DESIGN <i>CP</i>	DRAWN BY <i>CP</i>	DART AEROSPACE LTD HAWKESBURY, ONTARIO, CANADA	
CHECKED <i>#</i>	APPROVED <i>#</i>	DRAWING NO. D3016	REV. A SHEET 1 OF 3
DATE 01.05.18		TITLE SEAT FRAME ASSEMBLY	SCALE NTS
A	01.05.18	NEW ISSUE

DRAWING NO. D3016	TITLE SEAT FRAME ASSEMBLY	REV. A	DART AEROSPACE LTD ENGINEERING ORDER	D.E.O. NO. D3016-A-1	SHEET NO. SHEET 1 OF 1	SCALE NTS
DRAWN <i>1</i>	CHECKED <i>UP</i>	MFG. APPR. <i>RE</i>	APPROVED <i>MAP</i>	DE APPR. <i>TH</i>		
DATE 10.01.29	DATE 10.01.29	DATE 10.01.29	DATE 10.01.29	DATE 10.01.29

TO REVISE D3016-11 SADDLE'S HOLE SIZES

D3016-11 SADDLE

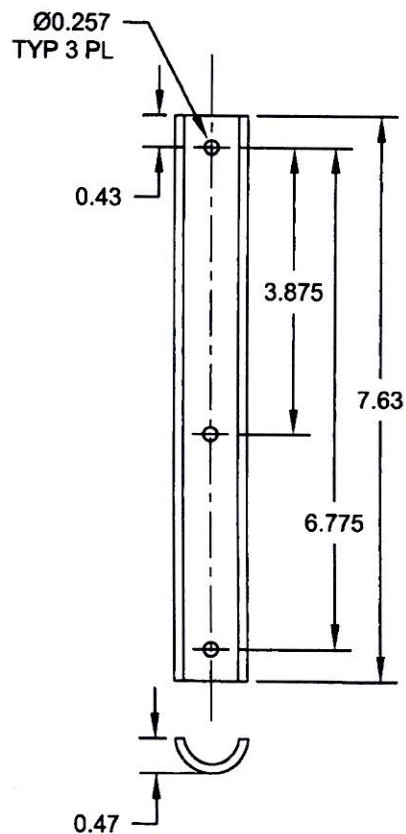
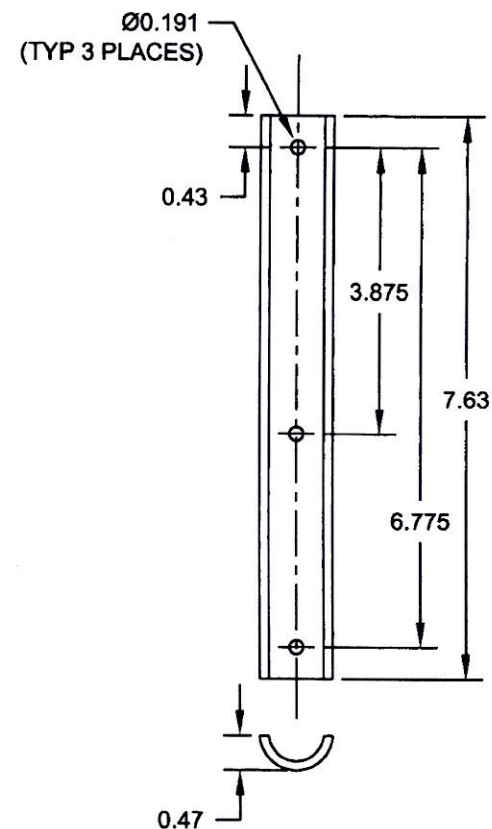
DETAIL D3016-11 SADDLE (SHEET 3): Ø0.257 TYP 3 PL WAS Ø0.191 (TYP 3 PLACES) AS SHOWN:
